SECTION 96 SUBMISSION

DEE WHY RSL CLUB - 932 PITTWATER ROAD  
STAGE 5 CLUB EXTENSION

DRAWING TITLE:  
CAR PARK LEVEL -2

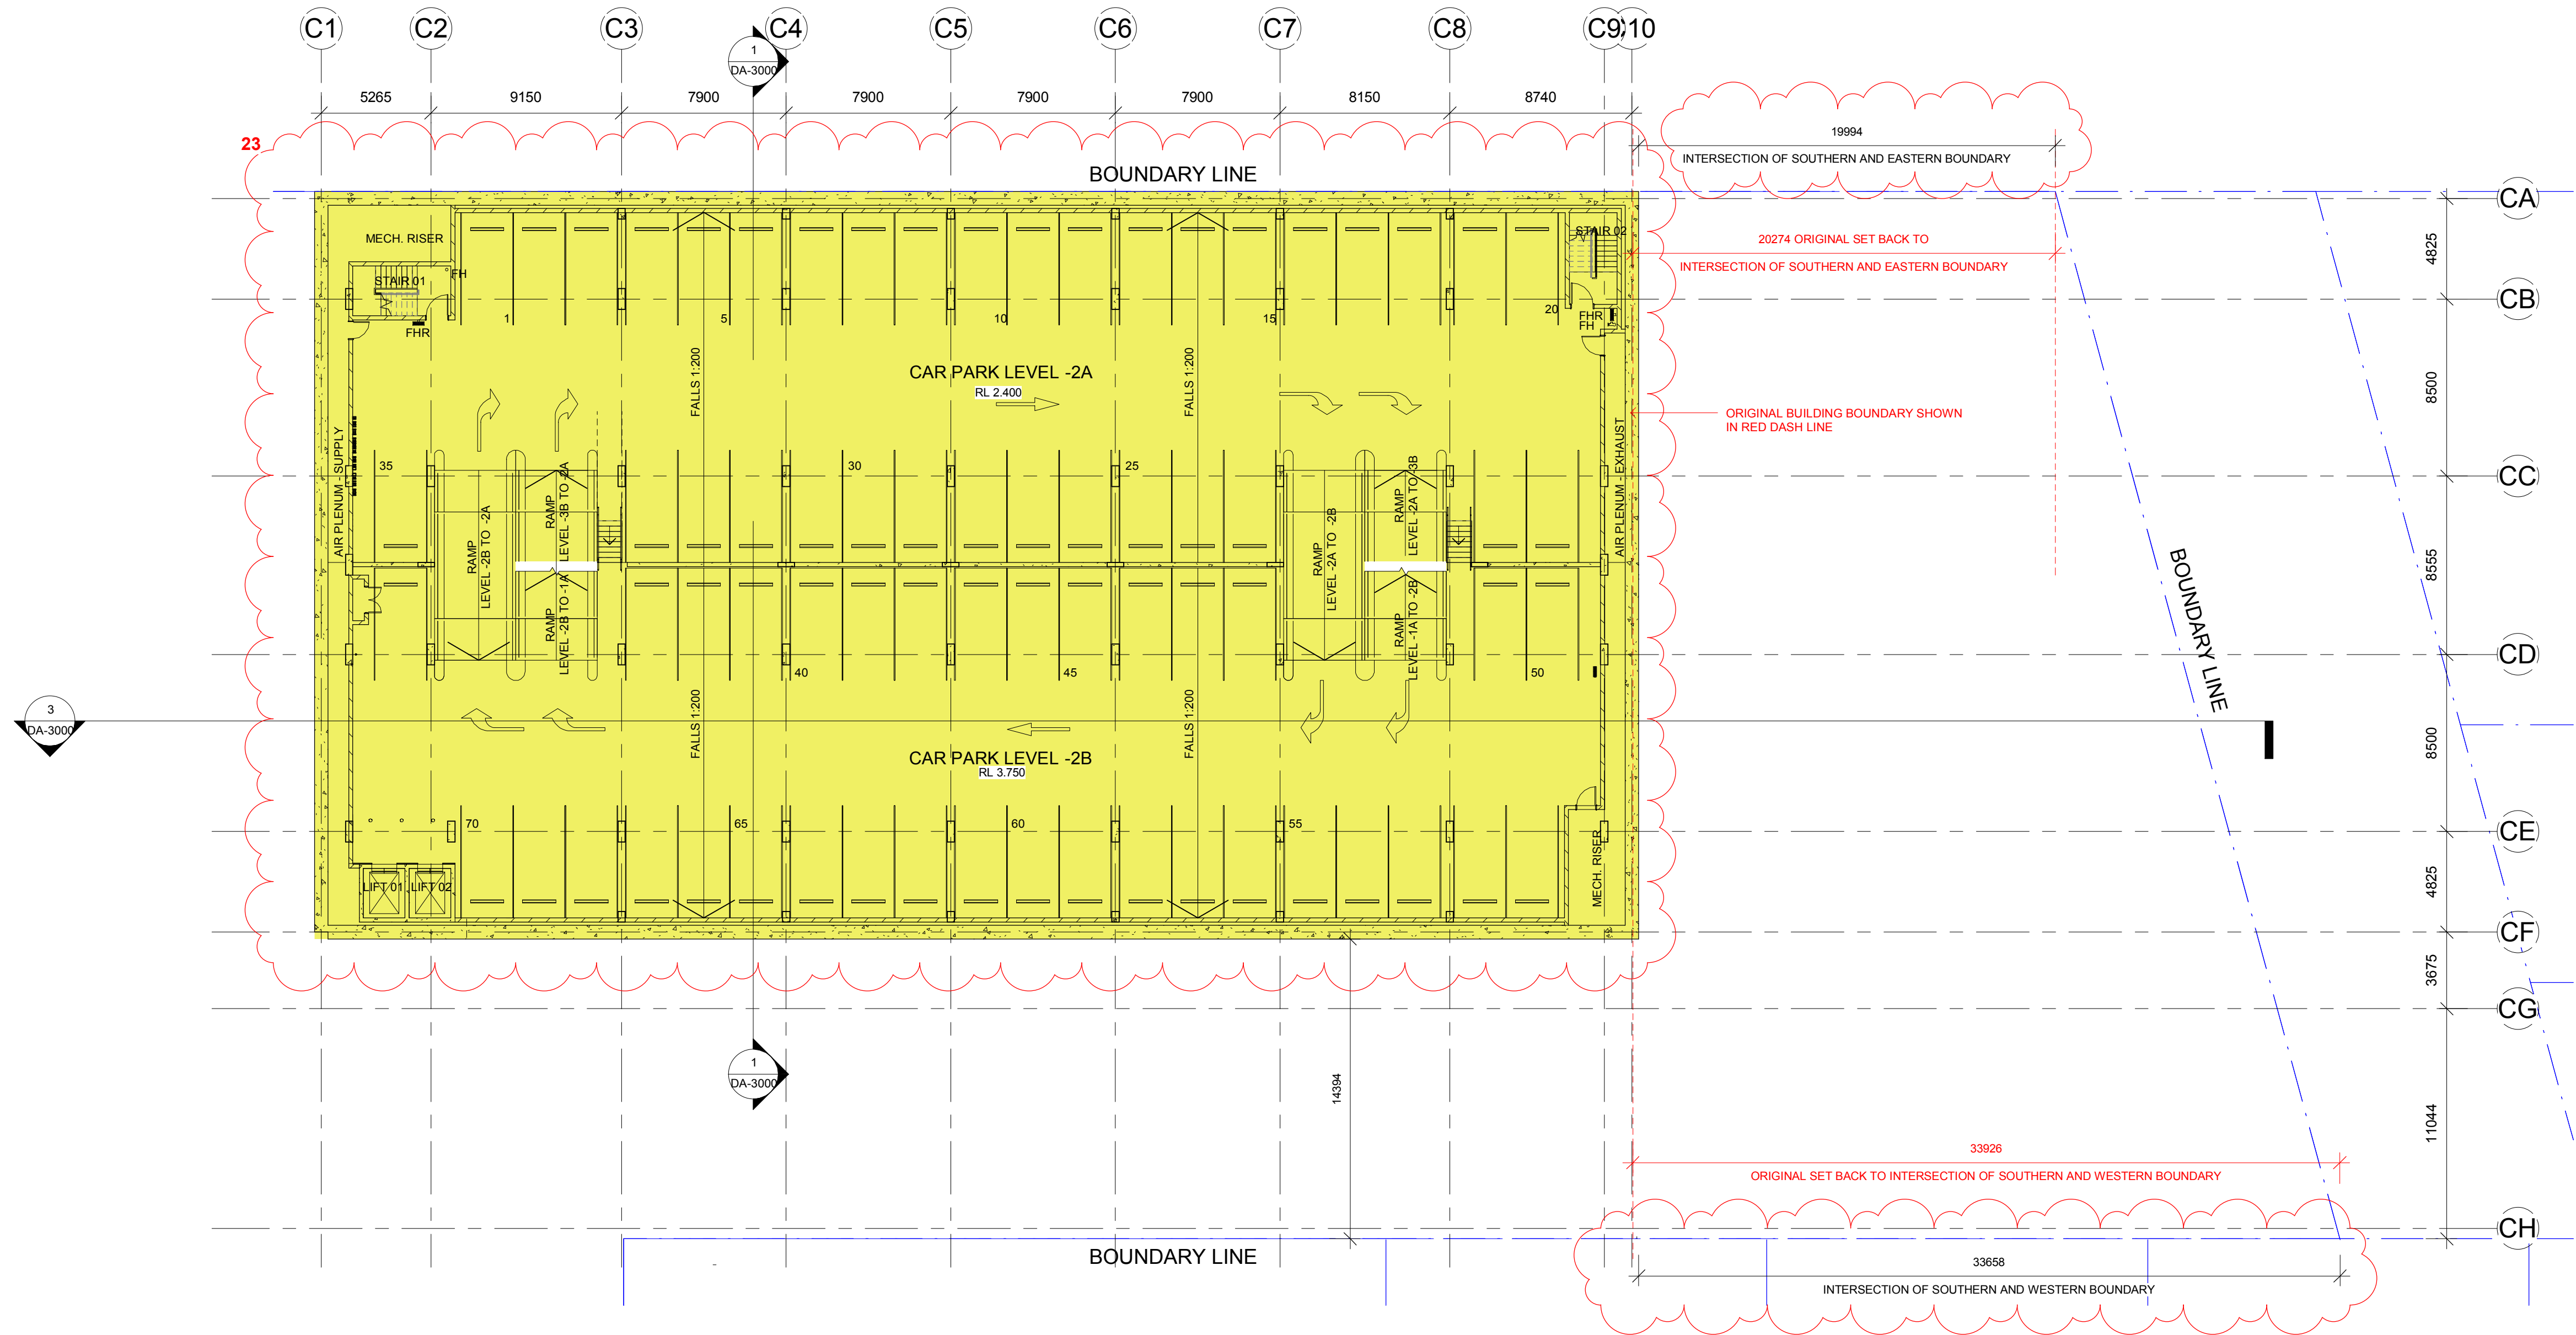
- ROOF  
1. RELOCATED OPEN PLANTROOM AT THE ROOF LEVEL  
2. MODIFIED ROOF OPENING ABOVE MAIN ENTRANCE  
3. MODIFIED CENTRAL SKYLIGHT (REDUCED HEIGHT, MODIFIED PITCH)  
4. MODIFIED COURTYARD: TWO OPEN COURTYARDS AND ONE SKYLIGHT COVERED AREA INSTEAD OF ONE LARGE GLASS ROOF. REDUCED HEIGHT AND PITCH  
5. MODIFIED SMOKING TERRACE, ROOF OPENING, SIZE AND PLANTED AREA, AREA REDUCED BY 21m²  
6. REDUCED NUMBER OF ROOF SKYLIGHTS ABOVE ASIAN RESTAURANT: 2 INSTEAD OF 6 TO SUIT THE NEW INTERNAL LAYOUT  
7. MODIFIED EXIT STAIR: POSITION, CONFIGURATION, METAL ROOF NO LONGER REQUIRED  
8. CONCRETE ROOF INSTEAD OF METAL DECK ROOF FOR THE MAJORITY OF THE BUILDING EXTENSION  
9. NO SLAB ABOVE THE EXPOSED CAR PARK LEVEL 2 IN THE SOUTH AREA  
10. NEW ACOUSTIC METAL ROOF ABOVE REVISED LOADING DOCK

- facade  
11. MODIFIED FACADE APPEARANCE DUE TO CHANGES IN THE CAR PARK LEVELS, LOADING DOCK AND EGRESS STAIRS  
12. REMOVED LOUVRES ON THE BACK FACADE (WESTERN FACADE) DUE TO MECHANICAL RISER NO LONGER REQUIRED / REVISED LOCATION FOR EGRESS DOORS  
13. 2m WIDE INTERNAL EGRESS STAIR MODIFIED INTO TWO 1m WIDE EXTERNAL STAIRS WITH DECORATIVE BALUSTRADES  
14. EXTENT OF LEVEL 2 (MAIN TRADING LEVEL) REDUCED BY 8326mm FROM THE SOUTHERN BOUNDARY AND INCREASED BY 1100mm TO THE EASTERN BOUNDARY  
15. MODIFIED FACADE CURTAIN WALL MULLION BLADES  
16. CONCRETE BLADE WALL REDUCED BY 1.47m IN HEIGHT AND 0.2m IN LENGTH  
17. VERTICAL FINS REMOVED FROM BACK WALL (WESTERN FACADE)

- ground/landscape/floor plate  
18. REVISED LOADING DOCK ENTRANCE AND LOCATION/ ENLARGED DEMOLISHED AREA IN THE EXISTING RETAINED SOUTHERN CAR PARK  
19. NEW / MODIFIED EGRESS PATHS FROM EXISTING CARPARK LEVEL -1. NEW CARPARK LEVEL 1.

20. RELOCATED ELECTRICAL SUBSTATION / LANDSCAPED AREA MOVED TO SUIT  
21. MEDIAN STRIP ADDED AT ENTRY TO PROVIDE PLACE OF REFUGE AND ENSURE WIDTH OF ENTRY/ EXIT IS LESS THAN 8M AS PER DA CONDITION 23

24. BASEMENT CAR PARK LEVEL -5 ADDED.  
25. CAR PARK ENTRY / EXIT MOVED TOWARD NORTH BY 3044mm  
26. PLANTER MODIFIED ON THE BACK (WESTERN) FACADE DUE TO REDUCTION OF THE MAIN TRADING FLOOR SLAB

27. LOCATION OF AIR INTAKE MODIFIED  
28. EXTENT OF RESTAURANT REDUCED BY 136m²  
29. CLUB ENTRANCE ACCESSIBLE RAMPS MODIFIED  
30. ONE ADDITIONAL EXISTING CAR PARK SPACE TO BE REMOVED FROM EXISTING NORTHERN CAR PARK

31. SOLID MASONRY WALL ADDED BETWEEN EXISTING ZONE D CAR PARK AND LOADING DOCK ACCESS.

| DRAWING NO:<br><b>DA-1103</b> | ISSUE:<br><b>2</b> |

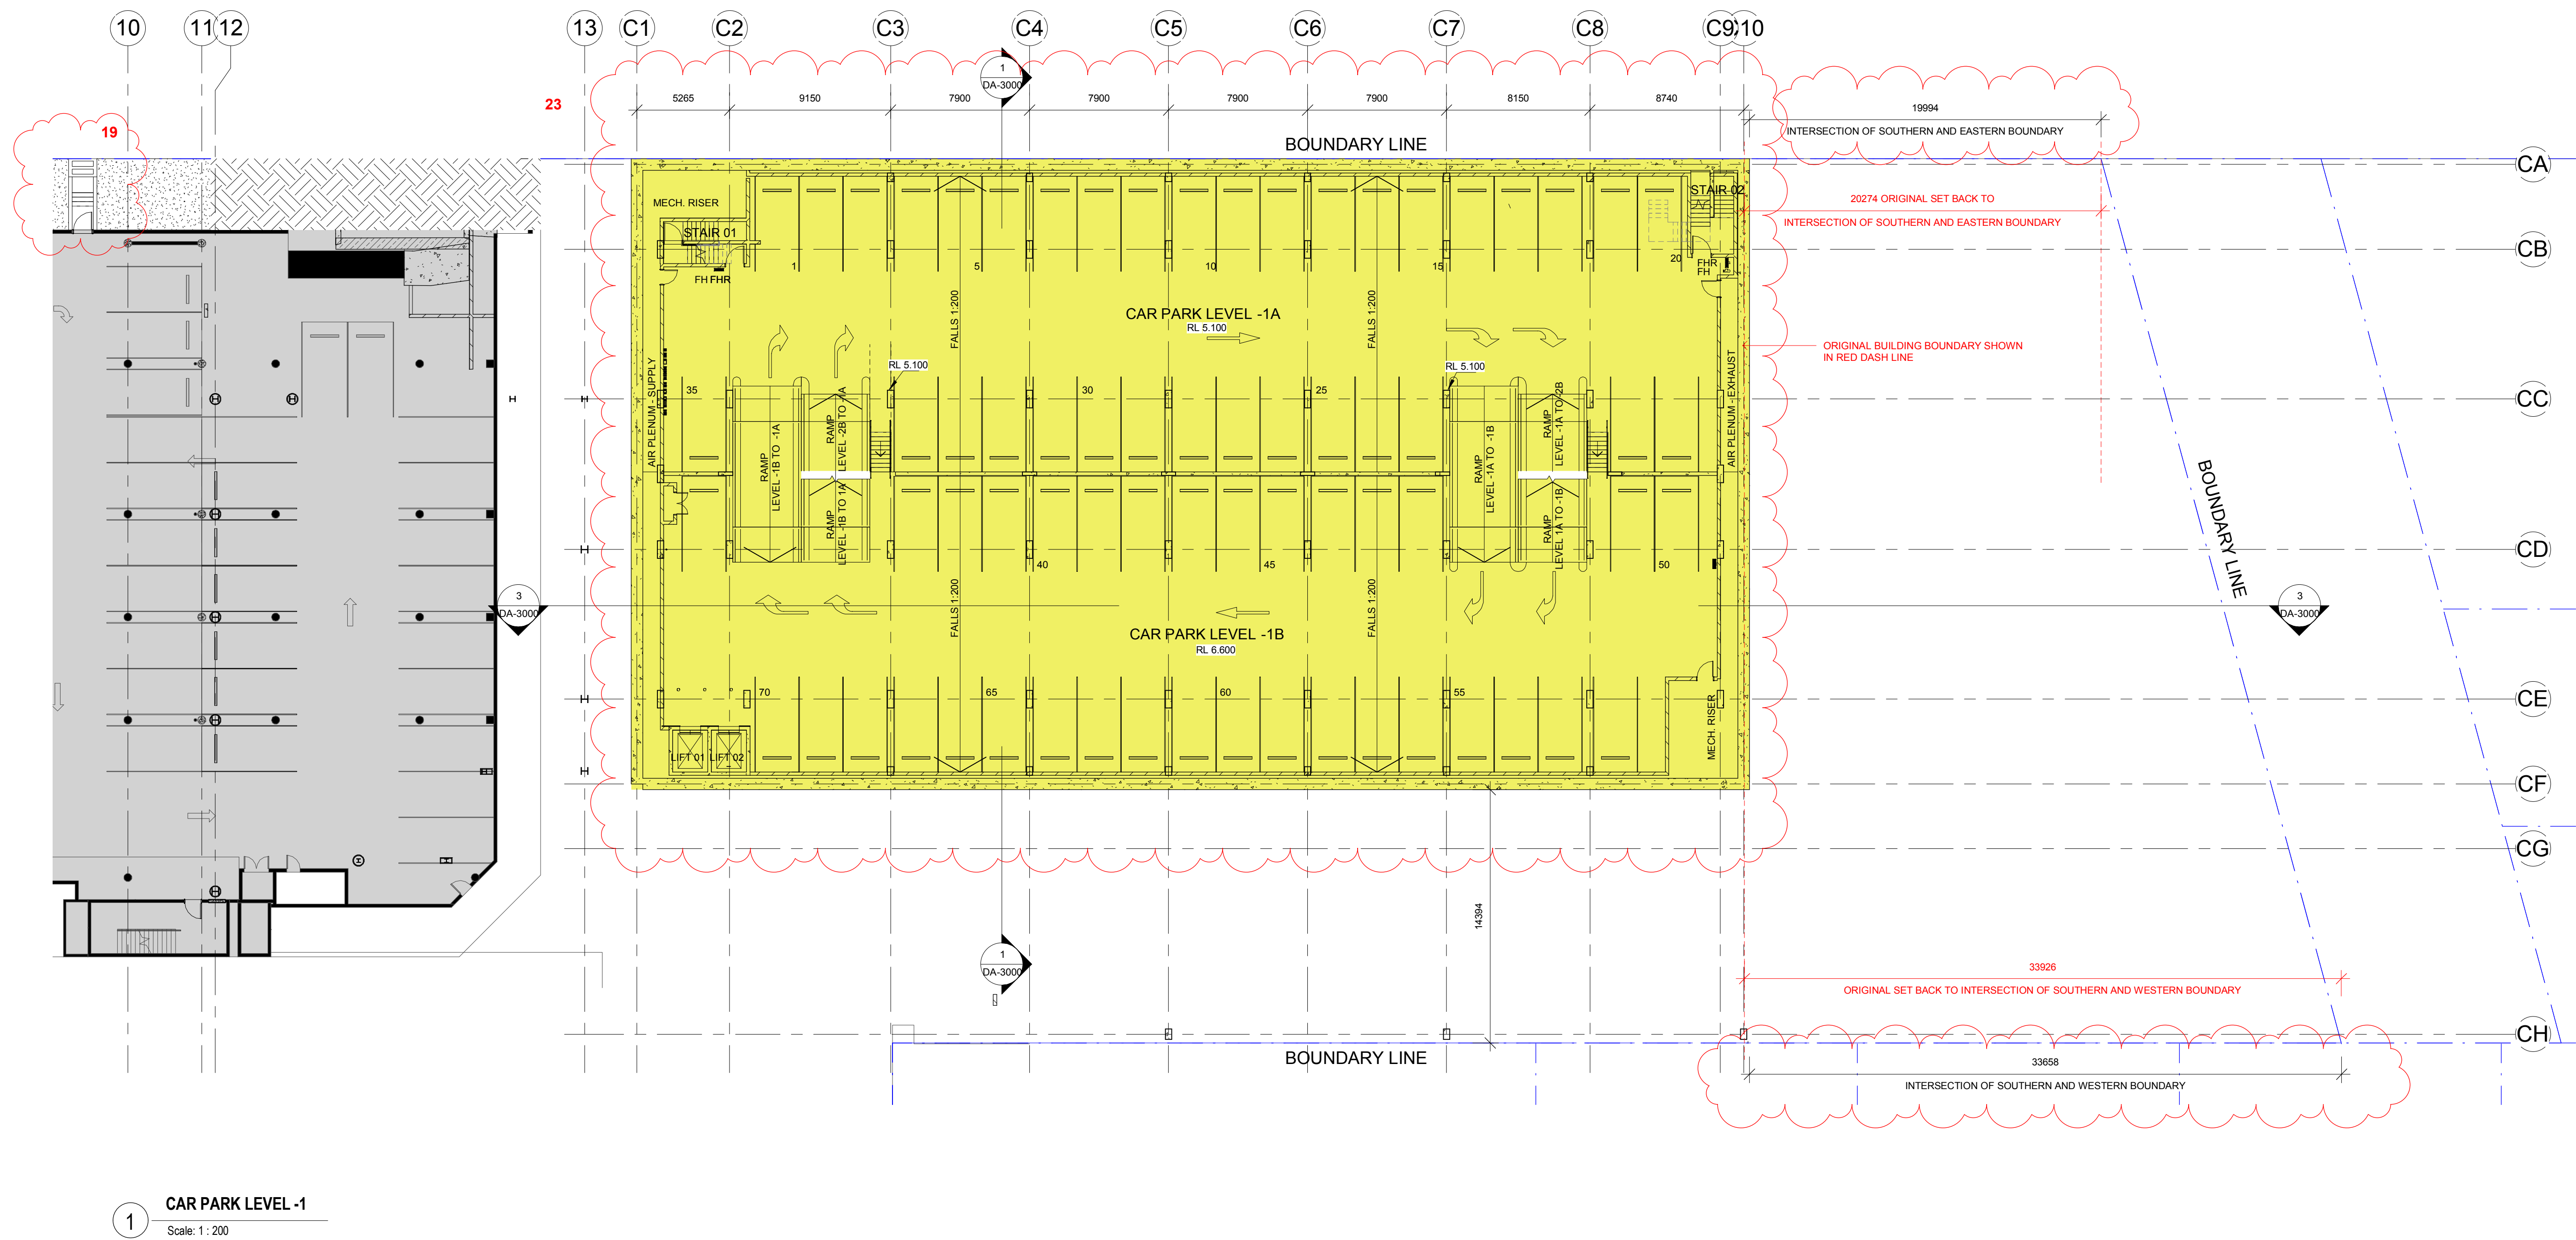
- 1. MODIFIED OPEN PLANTROOM AT THE ROOF LEVEL
- 2. MODIFIED ROOF OPENING ABOVE MAIN ENTRANCE
- 3. MODIFIED CENTRAL SKYLIGHT (REDUCED HEIGHT, MODIFIED PITCH)
- 4. MODIFIED COURTYARD - TWO OPEN COURTYARDS
- 5. MODIFIED SKYLIGHT COVERED AREA INSTEAD OF ONE LARGE GLASS ROOF REDUCED HEIGHT AND PITCH
- 5. MODIFIED SMOKING TERRACE: ROOF OPENING, SIZE AND PLANTED AREA. AREA REDUCED BY 21m<sup>2</sup>
- 6. MODIFIED NORTH SIDE OF ROOF OF SKYLIGHTS ABOVE ASIAN RESTAURANT: 2 INSTEAD OF 6 TO SUIT THE NEW INTERNAL LAYOUT
- 7. MODIFIED EXIT STAIR: POSITION, CONFIGURATION
- 8. METAL ROOF NO LONGER REQUIRED
- 9. CONCRETE ROOF OVER THE PLANT DECK ROOF FOR THE MAJORITY OF THE BUILDING EXTENSION
- 9. NO SLAB ABOVE THE EXPOSED CAR PARK LEVEL 2 IN THE SOUTH AREA
- 10. CONCRETE ACQUACQUA METAL ROOF ABOVE REVISED LOADING DOCK

11. MODIFIED FACADE APPEARANCE DUE TO CHANGES IN THE CAR PARK LEVELS, LOADING DOCK AND EGRESS STAIRS
12. REMOVED LOUVRES ON THE BACK FACADE (REMOVED REQUIRE) DUE TO MECHANICAL RISER NO LONGER REQUIRED / REVISED LOCATION FOR EGRESS DOORS
13. 2m wide INTERNAL EGRESS STAIR MODIFIED INTO TWO 1m wide INTERNAL STAIRS WITH DECORATIVE BALUSTRADES
14. EXTENT OF LEVEL 2 (MAIN TRADING LEVEL) REDUCED BY 8326mm FROM THE SOUTHERN BOUNDARY AND INCREASED BY 1100mm TO THE EASTERN BOUNDARY
15. MODIFIED FACADE CURTAIN WALL MULLION BLADES
16. CONCRETE CURTAIN WALL REDUCED BY 147mm IN HEIGHT AND 6.2m IN LENGTH
17. VERTICAL FINES REMOVED FROM BACK WALL (WESTERN FACADE)

18. REVISED LOADING DOCK ENTRANCE AND LOADING ENTRANCE DEMOLISHED AREA IN THE EXISTING REINFORCED SOUTHERN CAR PARK LEVEL 1. NEW / MODIFIED PATHS TO EXISTING CARPARK LEVEL - 1. NEW CARPARK LEVEL 1.

20. RELOCATED ELECTRICAL SUBSTATION / TRANSFORMER TO EXISTING PATHS
21. MEDIAN STRIP ADDED AT ENTRY TO PROVIDE PLACE OF REFUGE AND ENSURE WIDTH OF ENTRY IS LESS THAN 8M AS PER DA CONDITION 23

24. BASEMENT CARPARK LEVEL - 5 ADDED.
25. CAR PARK ENTRY / EXIT MODIFIED TOWARD NORTH BY 3044mm
26. ENTRY MODIFIED ON THE BACK (WESTERN) FACADE DUO TO REDUCTION OF THE MAIN TRADING FLOOR SLAB

27. LOCATION OF AIR INTAKE MODIFIED
28. EXTENT OF RESTAURANT REDUCED BY 136m<sup>2</sup>
29. CLUB ENTRANCE ACCESSIBLE RAMPS MODIFIED
30. ONE ADDITIONAL EXISTING CARPARK SPACE TO BE REMOVED FROM EXISTING NORTHERN CAR PARK LEVEL 1. ONE ADDITIONAL EXISTING ZONE D CARPARK AND LOADING DOCK ACCESS.
